ADD BLDG HT DIM.
(ALL ELEV'S) - PERMIT
REVIEW SET
REV 1

Elevations		
Project number	N/A	105
Date	N/A	
Drawn by	ICB	
Checked by	CGJ	
		Scale As indicated

4 South
1/16" = 1'-0"

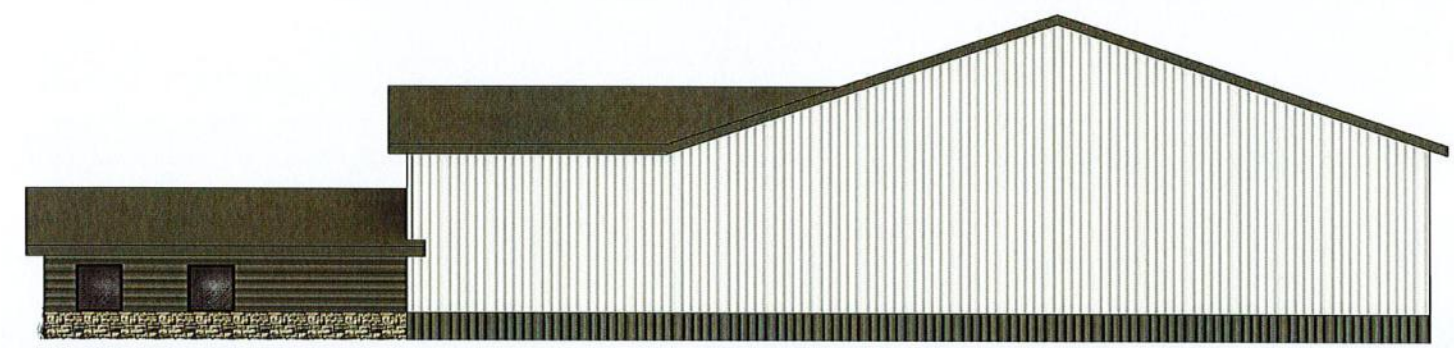
DR HDR 7'-0" - MIN
7'-4" IBC 1010.1.1

ADD PITCH CALLOUT
(~4:12)

SPEC PANEL MFR,
TYPE & COLOR

WAINSCOT - LABEL 4'-0" / GRAPHIC 3'-6" ?

place address numbers on building

OHD - ADD OPENING DIMS

1 East
1" = 20'-0"

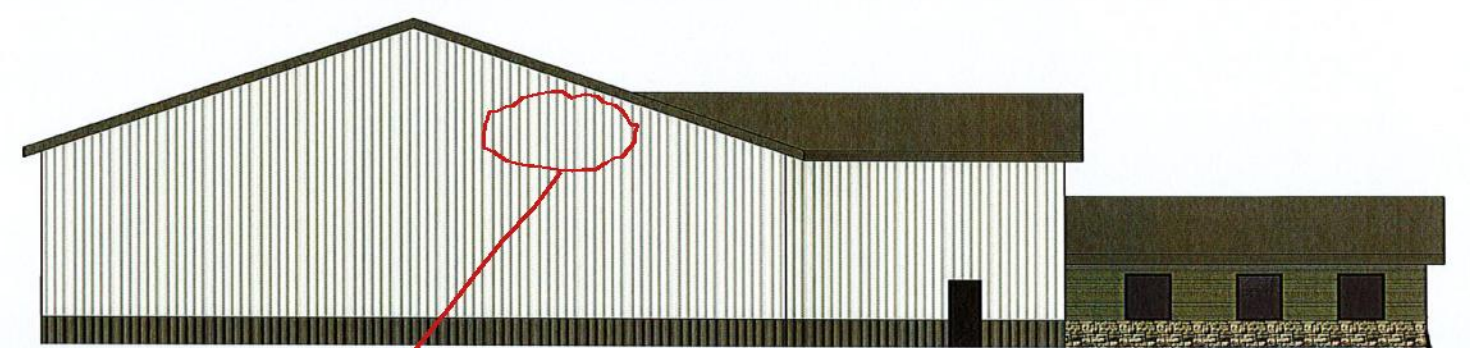
FG LINE - VERIFY MATCHES C-401
